Flex Car Spa & Lube  
Phase I Development  
10705 Central Avenue, NE  
Albuquerque, NM 87123

1	9-2-09	PLAN REVIEW COMMENTS
2	7-28-11	TCL REVIEW COMMENTS
Project Number		
Drawn By		
Checked		
Issue Date June 10, 2009		
ARCHITECTURAL SITE PLAN		
Scale: AS SHOWN		
PROJECT AS101		
OCT - 9 2014

**GRADING AND DRAINAGE PLAN**

1 ARCHITECTURAL SITE PLAN

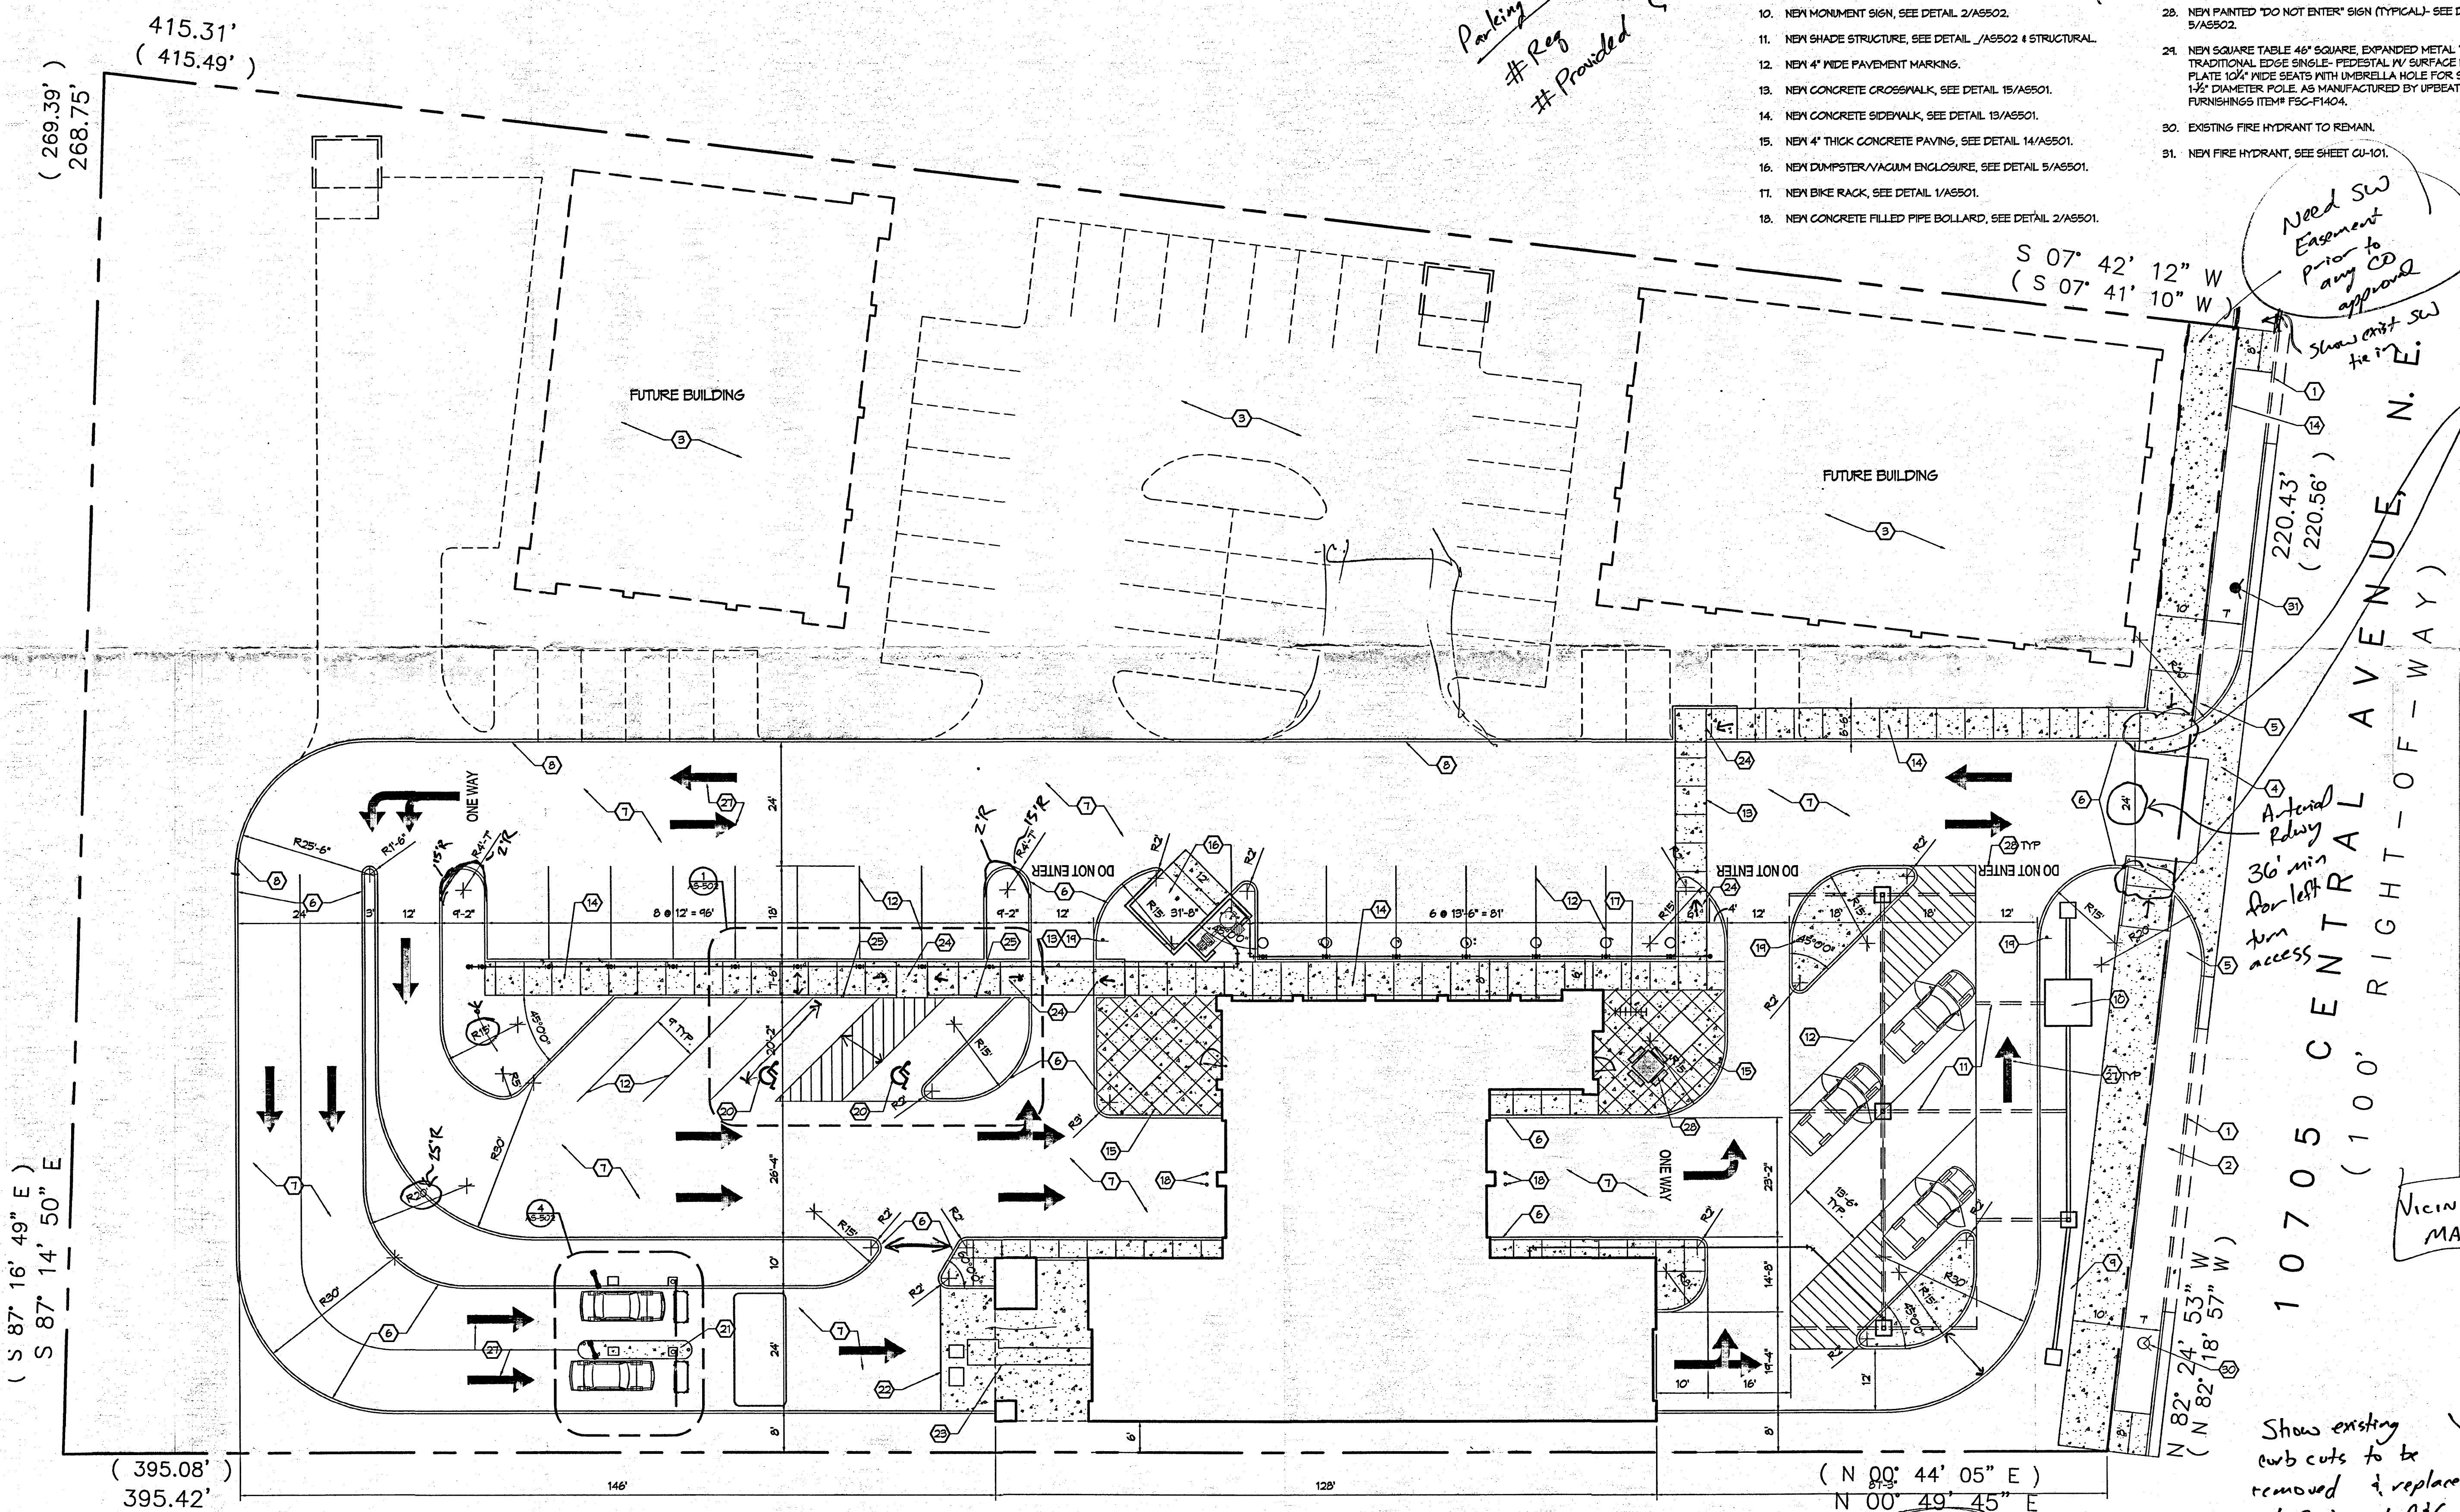
Need SW Easement prior to any CD approval  
Show exist SW tie in

Show existing curb cuts to be removed & replaced w/ SW and C16 (CoA Std 2415, 2430)
